ADDENDUM # 2

Title: Steam Pit Piping Renovations East Hall - URI

ADDENDUM #2

PROJECT: UNIVERSITY OF RHODE ISLAND
EAST HALL - STEAM PIT PIPING REVISIONS

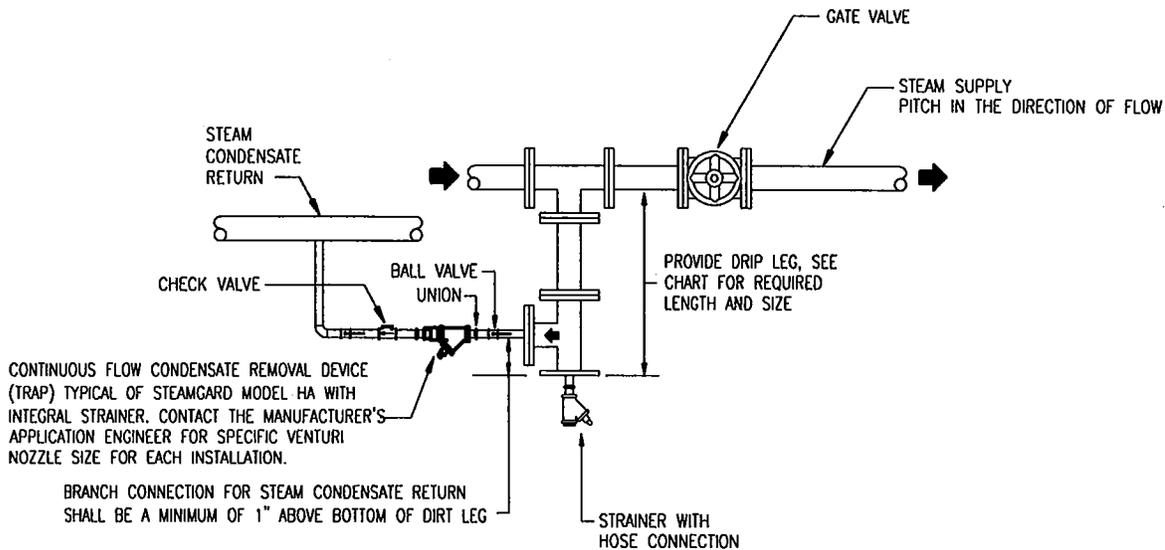
1. INSULATION ON PIPING WITHIN STEAM PITS: *What is the insulation requirement within the steam pits?*
 - 1.1. See Mechanical Specifications on Drawing M3.0, Part 2, Item 3 "Manhole Piping Insulation"
 - 1.2. In the specification on drawing M3.0, Part 2, Item 3.D. add:

Thickness as follows:

1. Piping 1-1/2" and smaller shall have a minimum insulation thickness of 1-1/2".
 2. Piping larger than 1-1/2" shall have a minimum insulation thickness of 3".
 3. Insulation thickness is based on a "k" value not exceeding 0.27 Btu per inch/h•ft²•°F
2. CONDENSATE PUMP SIZE: *The spec calls out a 2 HP condensate pump; this model is not available in a 2 HP.*
 - 2.1. The pump is ½ HP, and the correct model number is "2P-1/2-2HT"
3. DRIP LEG DETAIL: *The piping schematic refers to a "Drip Leg Detail"; detail not found.*
 - 3.1. See attached M-SK1 "Steam Condensate Drip Leg Detail".
